UNITED STATES  
DEPARTMENT OF THE INTERIOR  
BUREAU OF LAND MANAGEMENTNM OIL CONSERVATION  
ARTESIA DISTRICT  
OCD Artesia  
OCT 13 2015FORM APPROVED  
OMB NO. 1004-0135  
Expires: July 31, 2010**SUNDRY NOTICES AND REPORTS ON WELLS**  
*Do not use this form for proposals to drill or to re-enter an abandoned well. Use form 3160-3 (APD) for such proposals.*5. Lease Serial No.  
NMNM15295

☐ Oil Well ☒ Gas Well ☐ Other8. Well Name and No.  
CK 7 FEDERAL 002

**Permanent Abandonment of Federal Wells  
Conditions of Approval**

C K 7 Federal #2

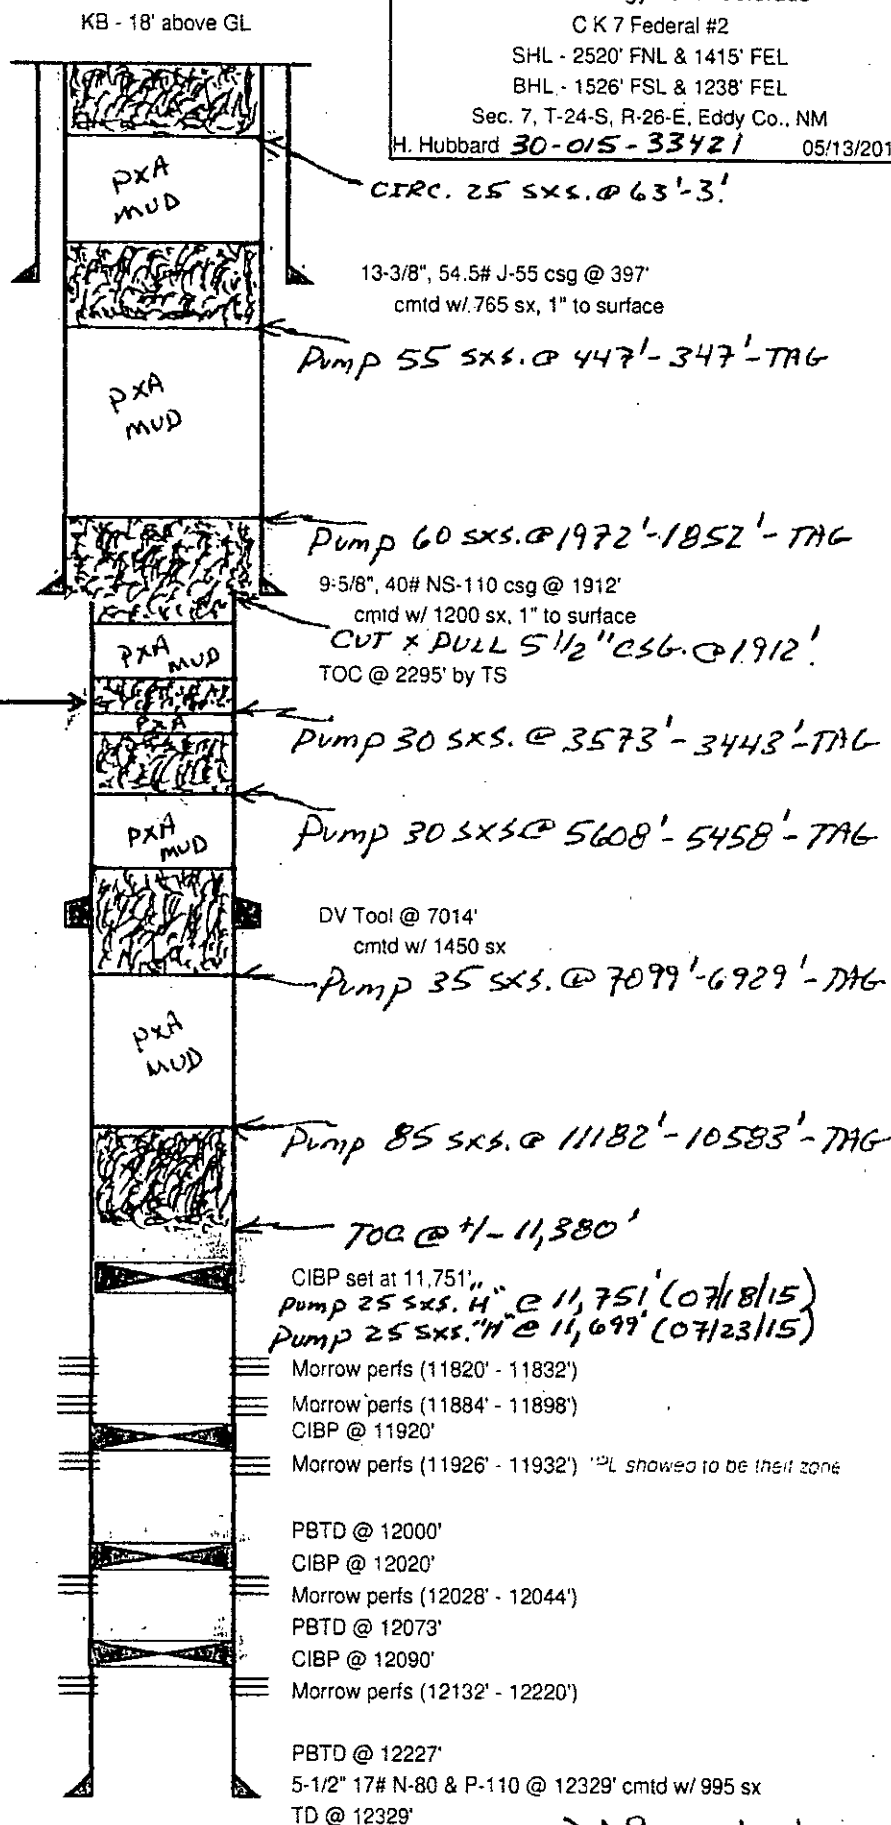
- 1) TAG EXISTING 5-1/2" CIBP + CMT. @ +/-11,380'; ATTEMPT TO CIRC. WELL.  
2) PUMP 85 SXS.CMT. @ 11,182'-10,583'(T/ATOKA,T/STWN.); WOC X TAG CMT. PLUG. Add plug from 9950-8880.

3) PUMP 35 SXS.CMT. @ 7,099'-6,929'(5-1/2"DV TOOL); WOC X TAG CMT. PLUG. (T/WC)  
4) PUMP 30 SXS.CMT. @ 5,608'-5,458'(T/B.S.); WOC X TAG CMT. PLUG.  
5) PUMP 30 SXS.CMT. @ 3,573'-3,443'(POSS.5-1/2"CSG.PART); WOC X TAG CMT. PLUG. Add plug 2668-2548. Tag

6) CUT X PULL 5-1/2" CSG. @ +/-1,912'-2022' 2022' (cut/Ann) 2072'-1852'  
7) PUMP 60 SXS.CMT. @ 1,972'-1,852'(5-1/2"CSG.STUB,9-5/8"CSG.SHOE); WOC X TAG. 278.
